ADDENDUM NO. CC-2

TELEGRAPH DISTRICT
401 BUILDING RENOVATION
LINCOLN, NEBRASKA
DLR GROUP PROJECT NO. 10-16202-00
MARCH 18, 2016

COMBINED CONTRACT

C:\Rev\10-16202-00_AR_2016_Central_miniberg@dlrgroup.com.rvt
3/16/2016 2:28:43 PM

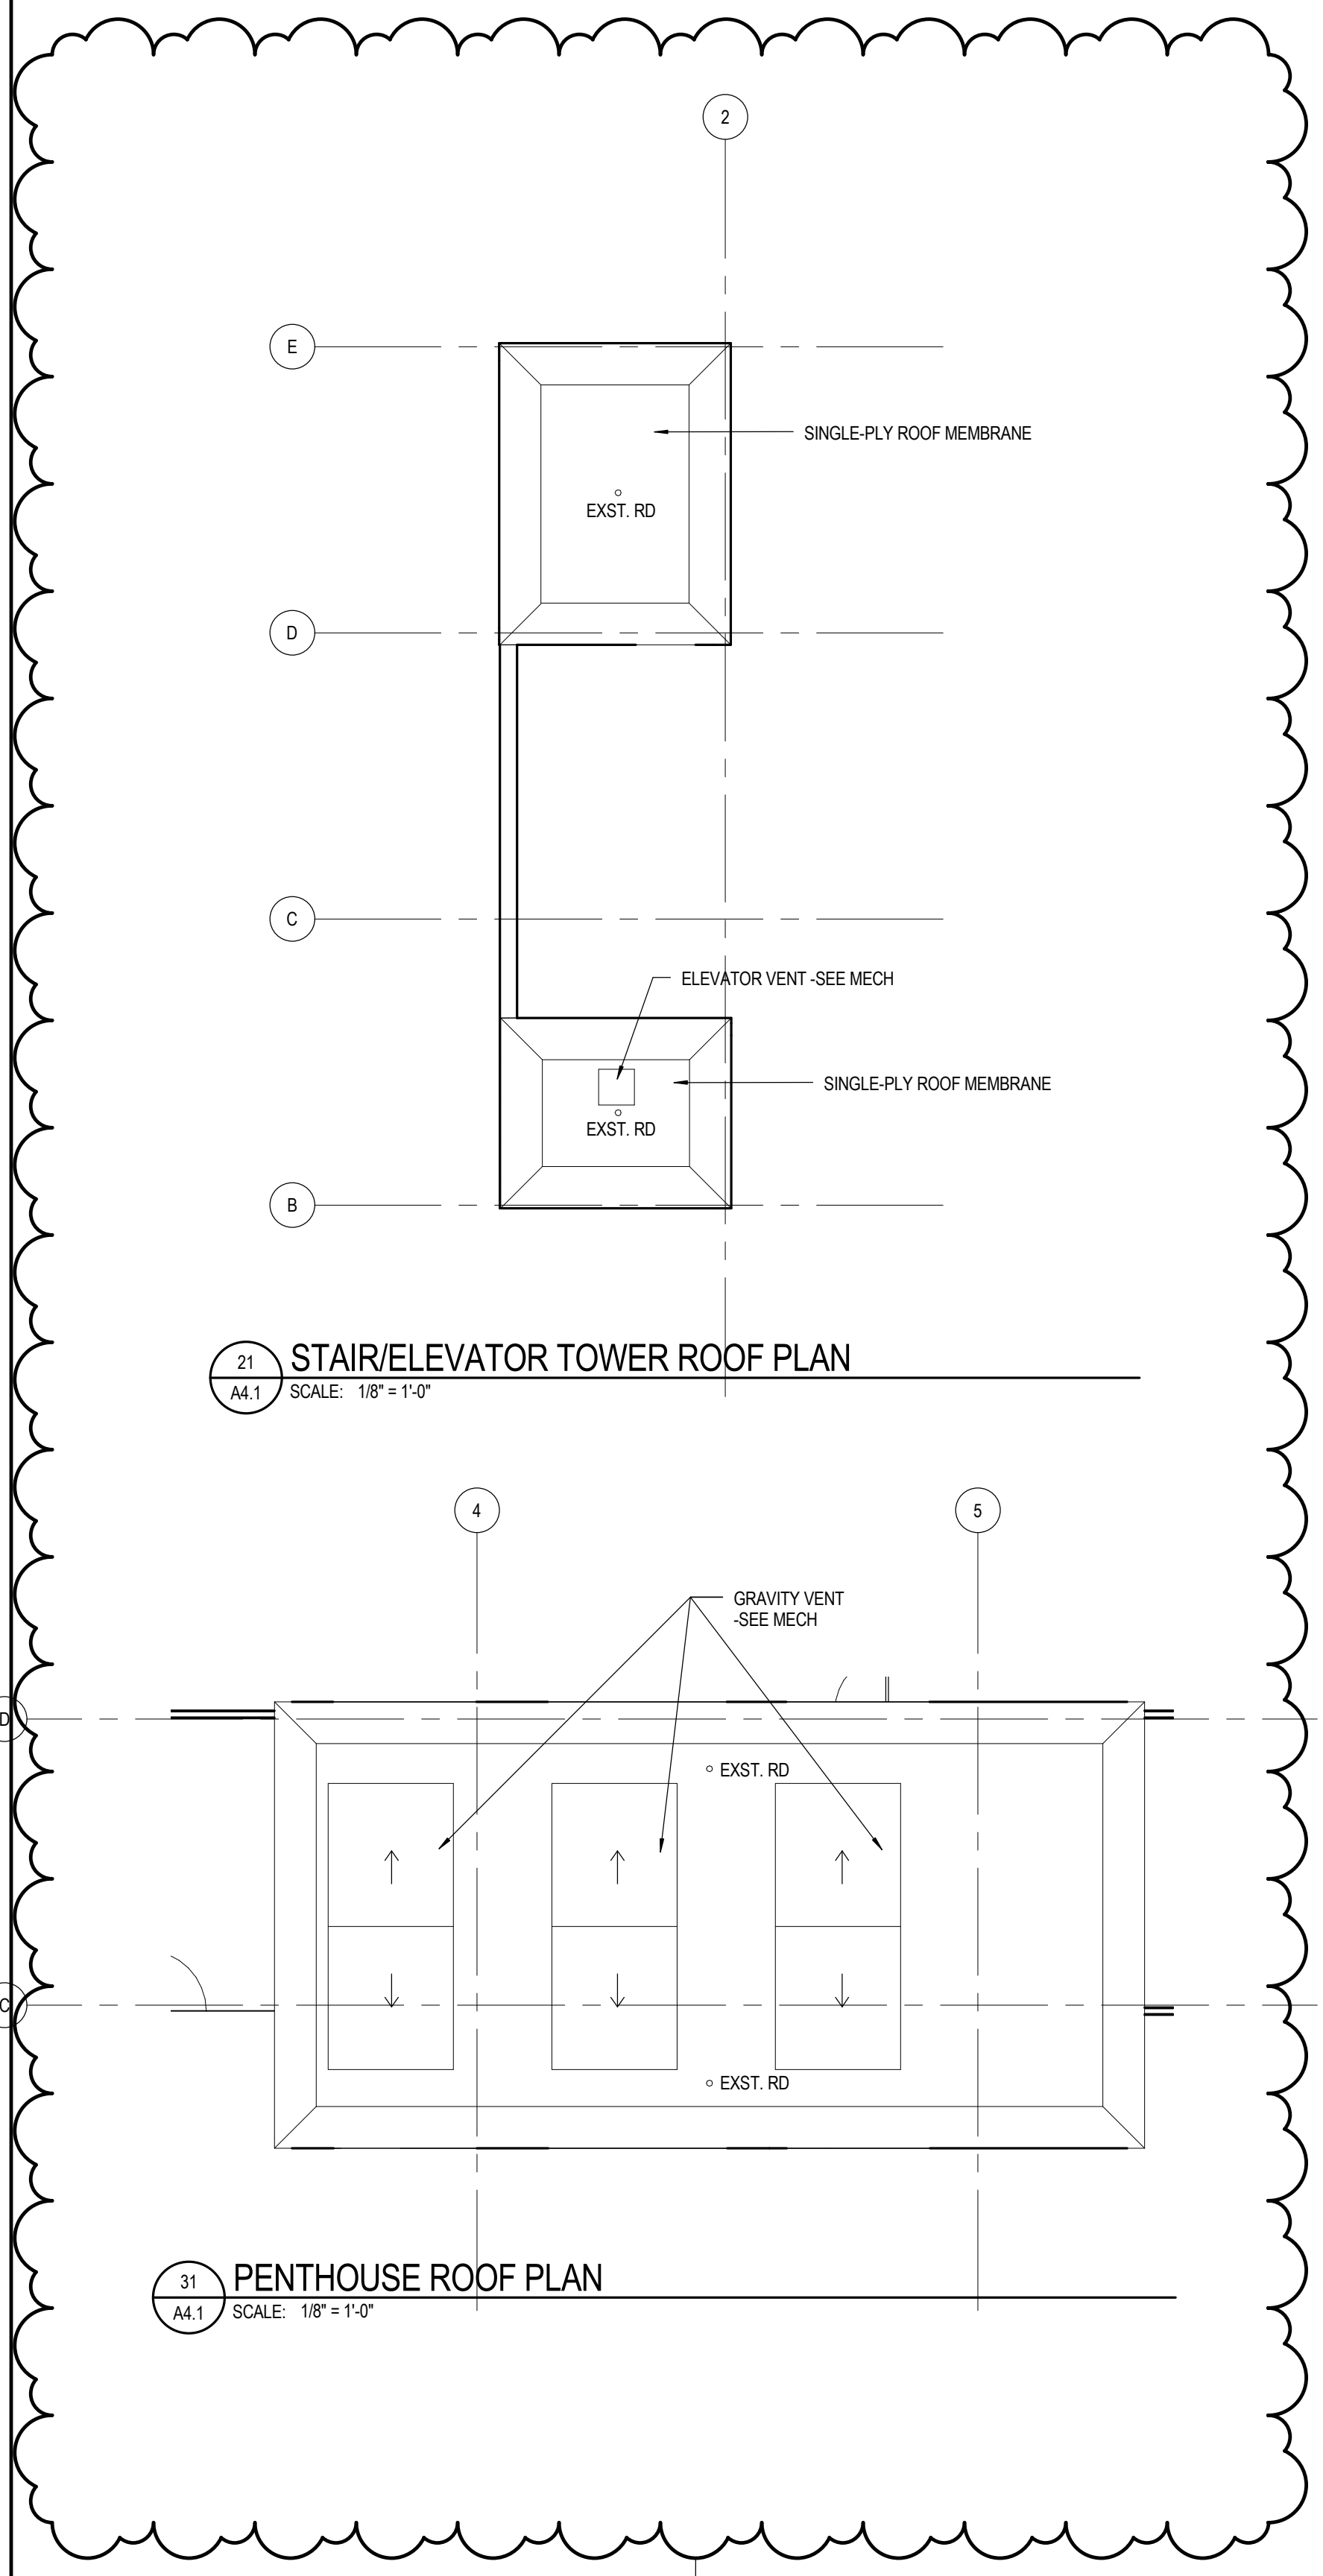
ITEM NO. 6 DRAWING A3.3 REFLECTED CEILING PLAN, THIRD LEVEL

- A. Revised drawing showing Sound Absorbing Ceiling Units.

Attachment No. A10.2-1
to A10.2
Dated: 3-18-16

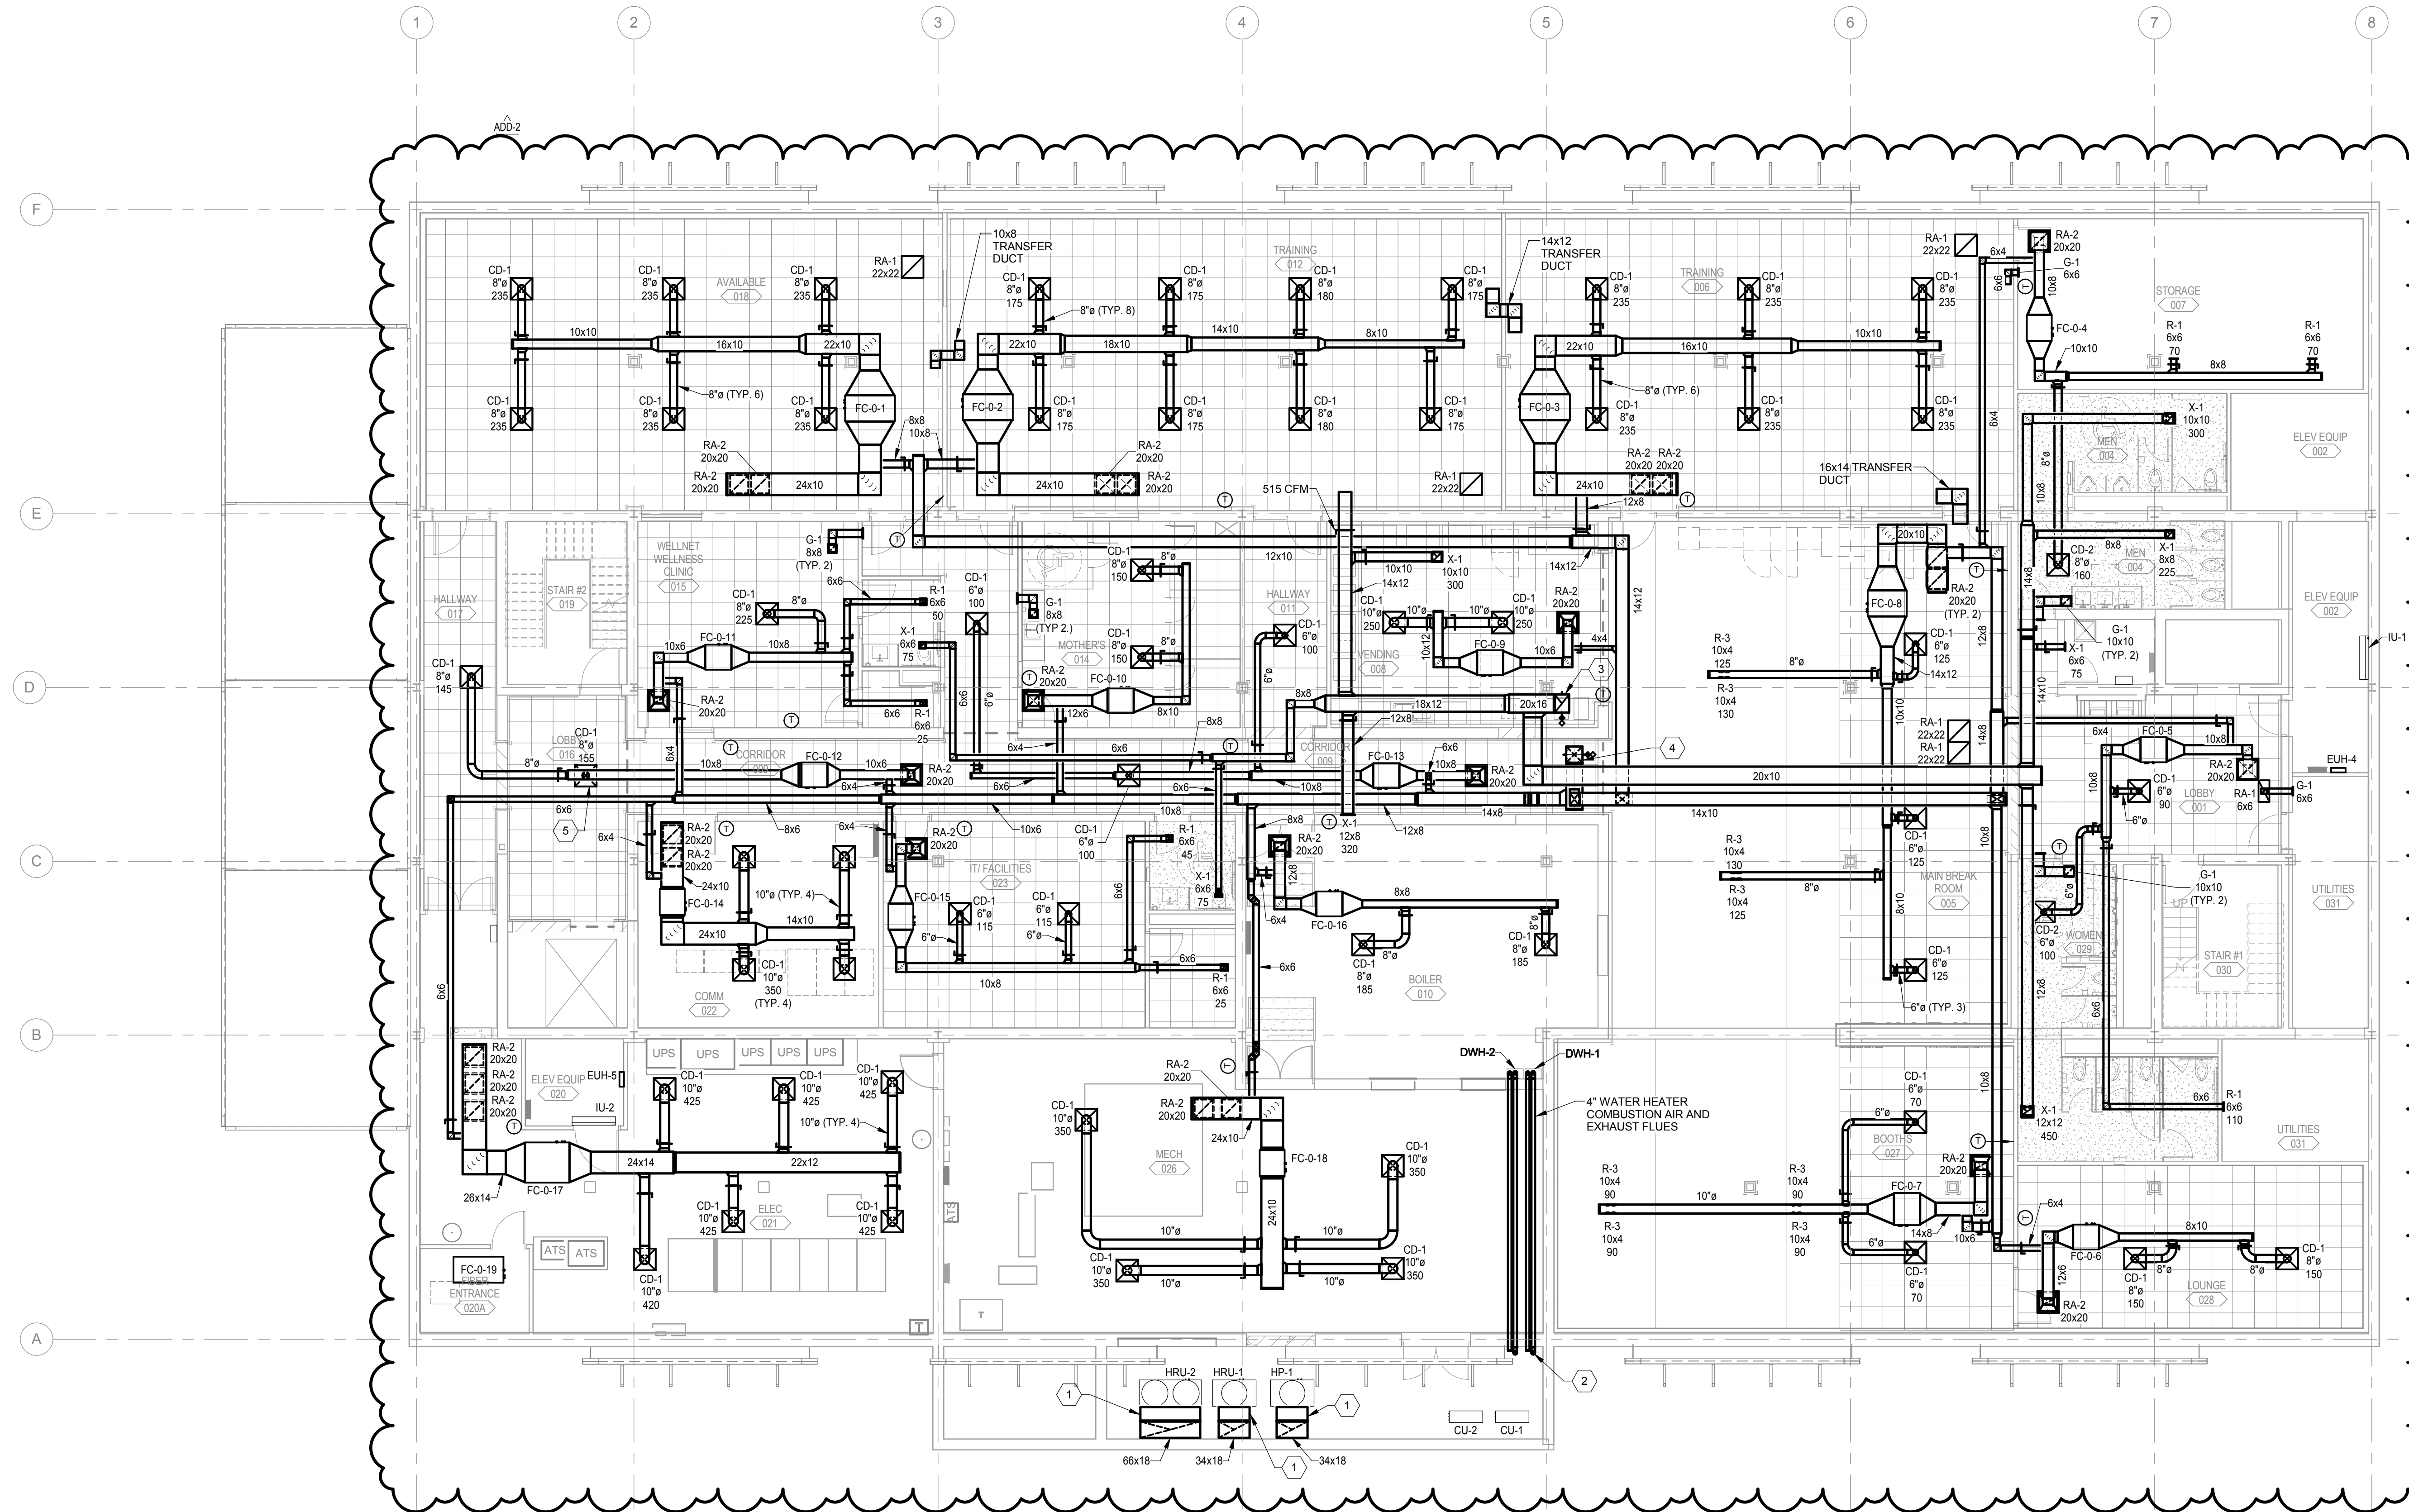
ITEM NO. 9 DRAWING A10.2 GENERAL BUILDING DETAILS

- A. Modify drawing as shown on Attachment A10.2-1.

HVAC PLAN, BASEMENT LEVEL
SCALE: 1/8" = 1'-0"
NORTH

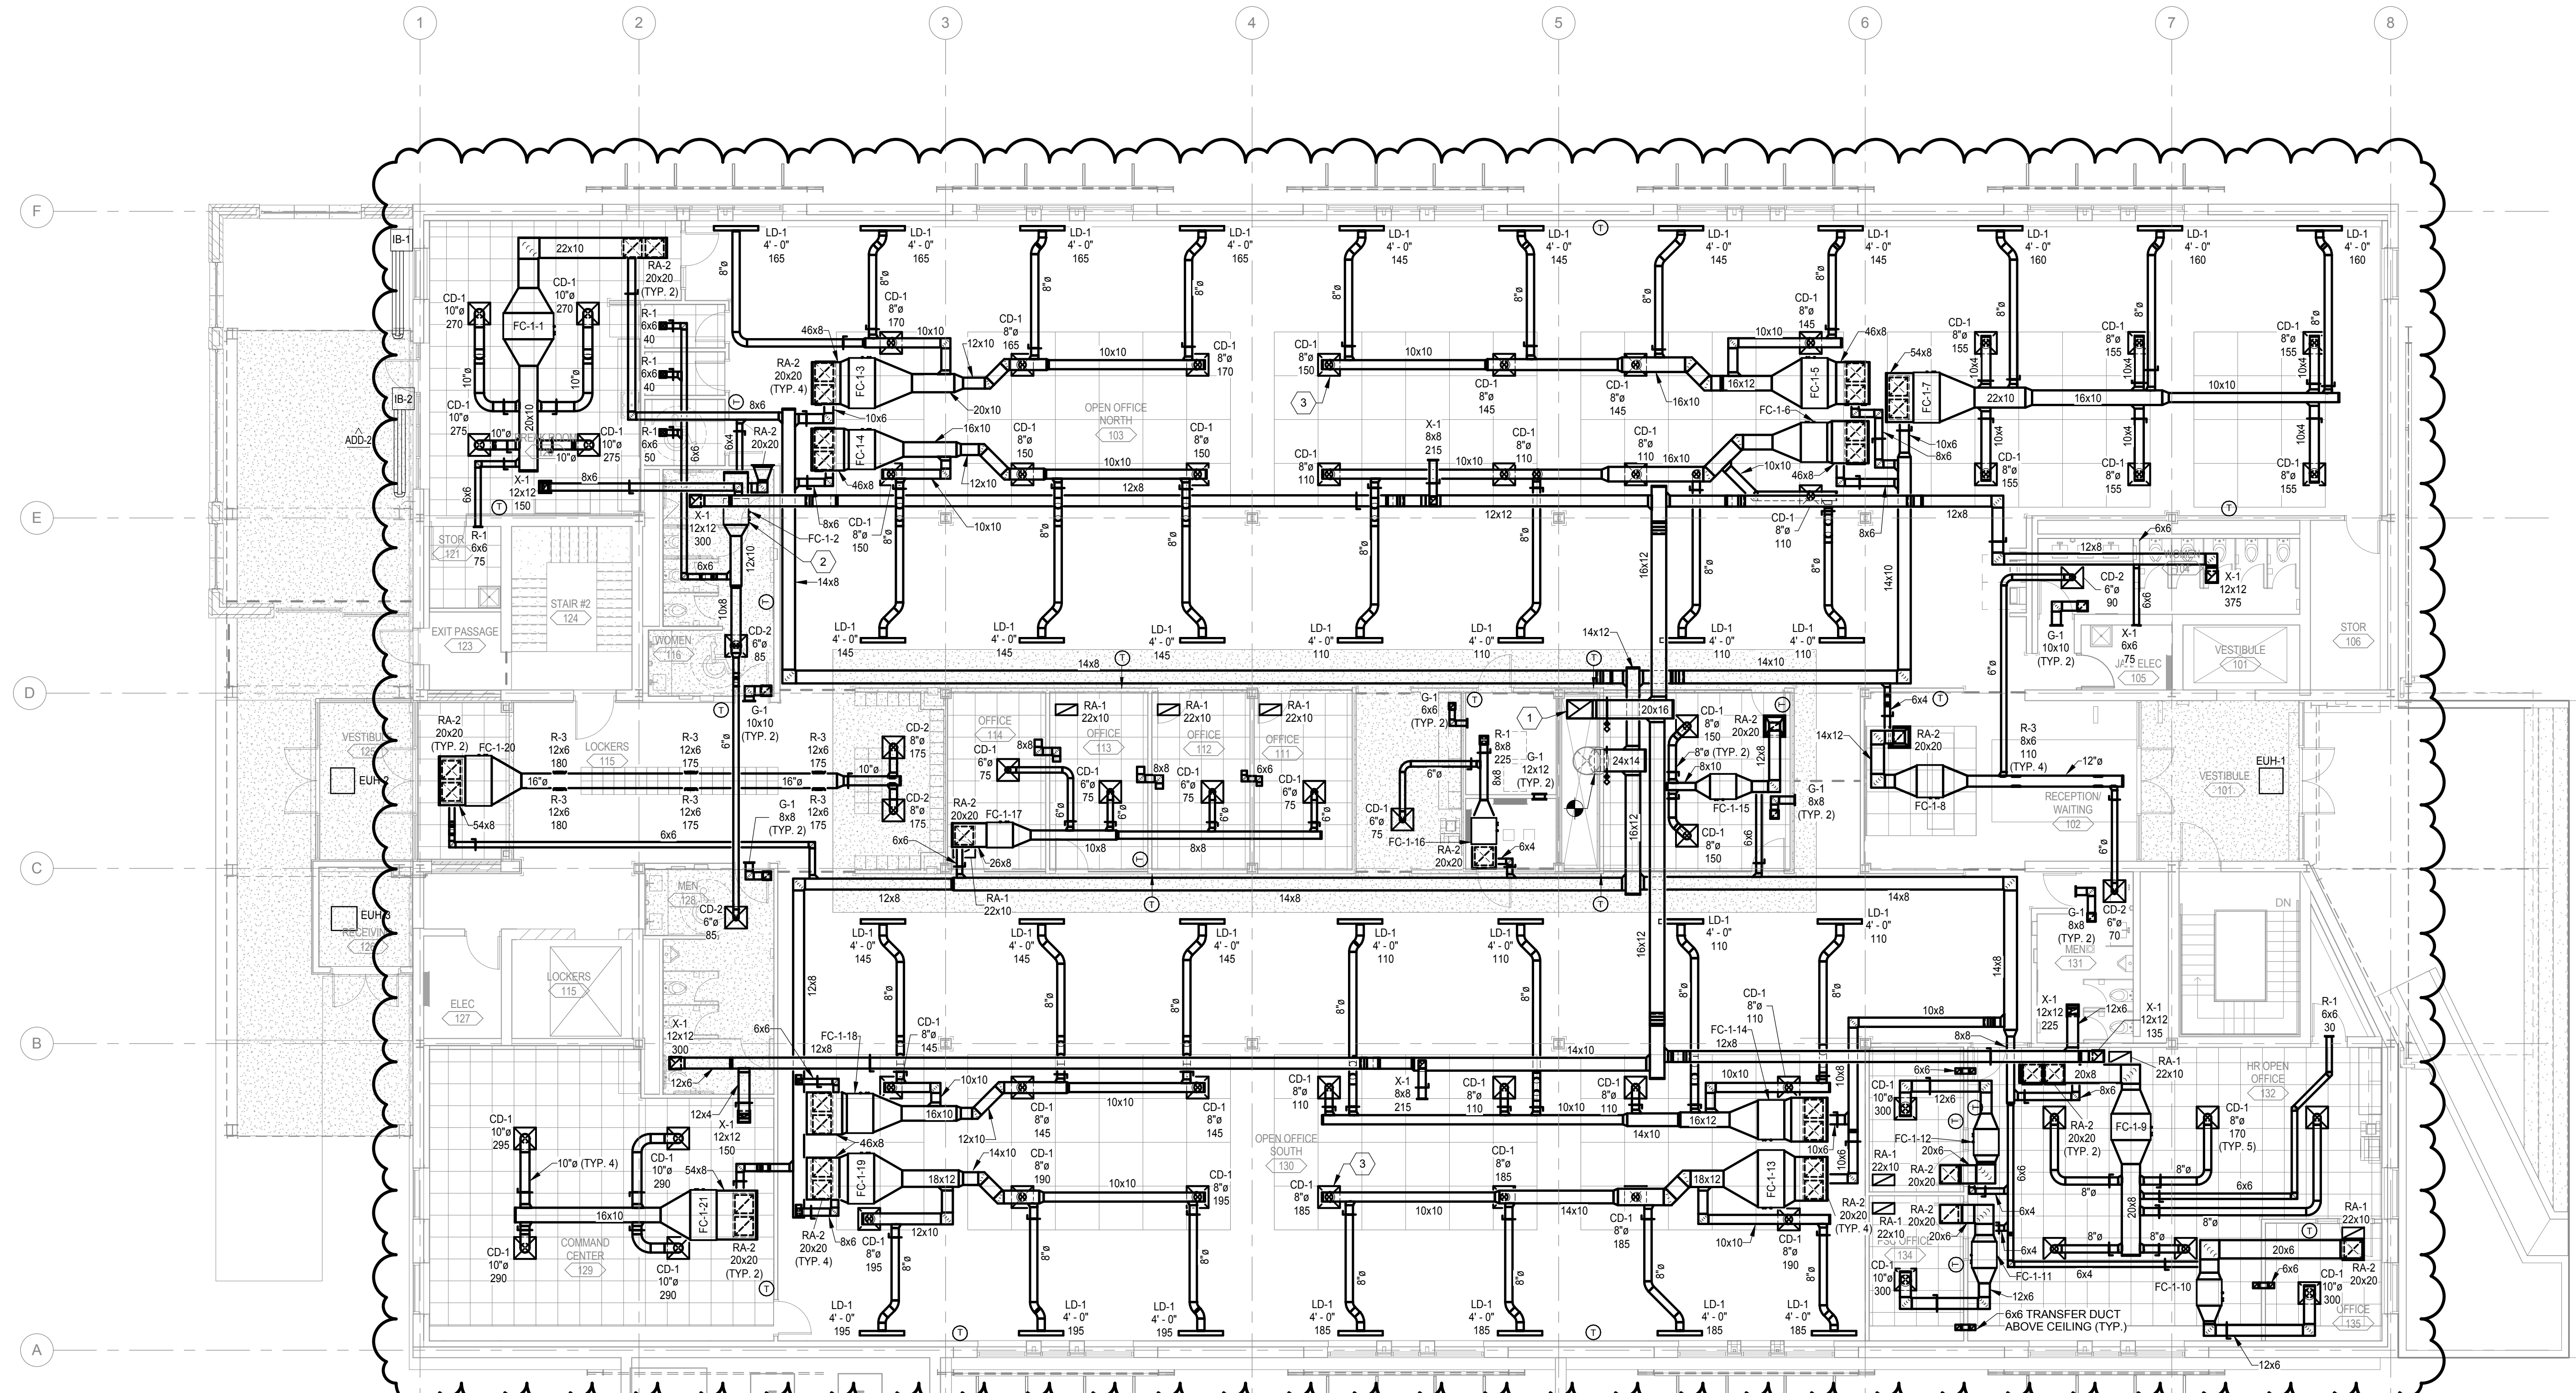
ITEM NO. 11 DRAWING M1.0 HVAC PLAN, BASEMENT LEVEL

- A. Revise the drawing as shown in the attachment M1.0 for modifications to the HVAC plan.
